RE: Comments on the September 16 Concept of the Proposed NIOSH Certification Standard for Chemical Biological Radiological Nuclear Air Purifying Respirator Standard per Proposed NIOSH Certification Standard for APR CBRN Federal Register Notice May 31, 2002 (Vol.67, Number 105, pg. 38127-38128)

3M OH&ESD Comments on the September 16 2002 Version of the APR CBRN Concept

Figure 1: Internal Thread

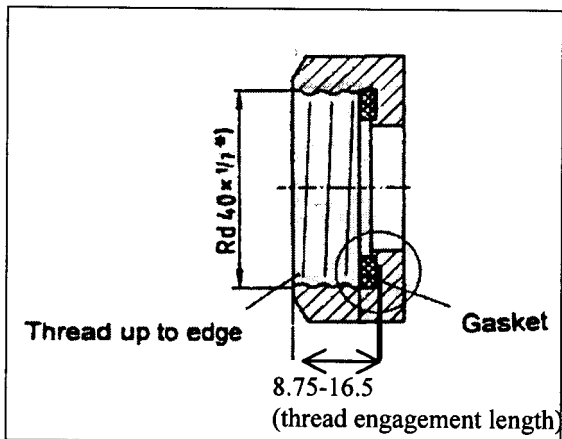
While the specified thread in all three documents is RD 40 x 3.63 mm, the internal thread depth on the facepiece specified in the M40 Military Specification PD-EA-M-1801/E5-1-1054/D-1-1076 (Mil Spec) is shorter than what is required by EN 148-1 and NATO STANAG 4155. This was done to provide a lower profile full-face and faster canister attachment. It is important to note that this shorter internal thread is still compatible with the longer external thread of the EN 148-1. The internal thread height specification of EN 148-1 requires a thread engagement length (distance from bottom of gasket to edge) to be 15-16.5 mm, while the Mil Spec requires 8.75-9.25 mm. Because the M40 is compatible with the C2A1 and EN 148-1 canisters we suggest adapting the high end number (15-16.5 mm) for the internal thread from the EN 148-1 standard, and the low end of the Mil Spec (8.75-9.25 mm) to make an internal thread length recommendation of 8.75-16.5 mm. Opening up the internal thread depth specification to accommodate both internal thread designs will allow existing US Military and First Responder respirator designs to be part of CBRN. This is shown in Figure 1.

Parameter	Requirement (mm)
Internal Thread – Thread Engagement Length	8.75 – 16.5 mm
External Thread – Run Out Length	15 mm
Gasket Thickness (minimum / maximum)	1.5 mm / 2.5 mm

Figure 2: External Thread

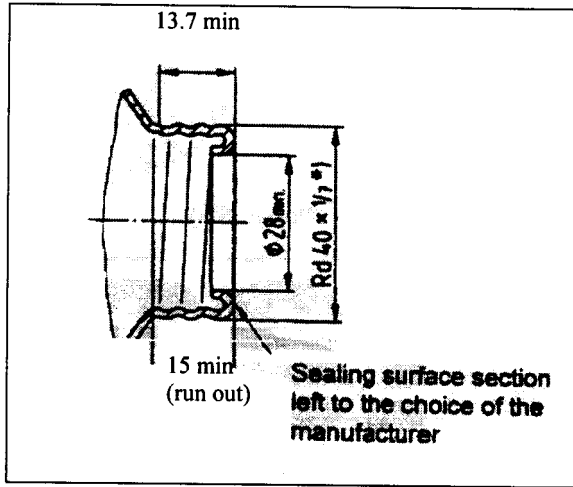
The NATO STANAG 4155 and EN 148.1 have a minimum external (male) thread run out of 16 mm, while the US Military Standard for the C2A1 minimum external male length is 15 mm. These minimum run out requirements are required to ensure the canister will seal with the gasket. Since the C2A1 canister is compatible with the EN 148-1 internal threads, we recommend establishing the C2A1 minimum run out of 15 mm as the standard minimum run out for the APR CBRN standard. This is shown in Figure 2.
